### **Amendments to the Drawings**

Replacement Sheet

SB MIZIKOVSKY 25

FIG. 3B

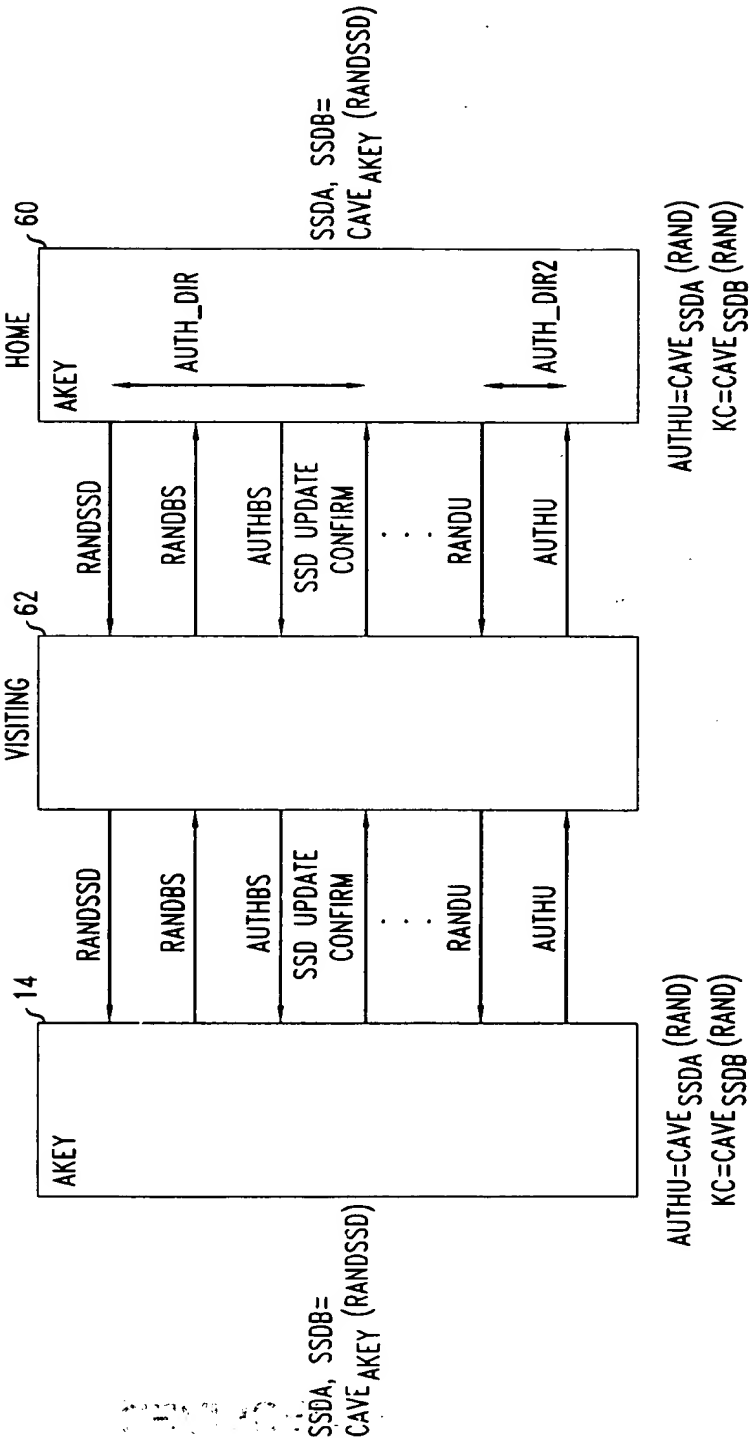
New formal drawings are being submitted herewith for the application. Amendments to the drawings were made to put the drawings in conformance with the written description. In FIG. 3B, AUTHREQ was deleted, and in FIG. 4, SSD\_KEY was made the output of function (F0) 67 and SSD\_NEW the output of function (f1) 68 on the unit side.
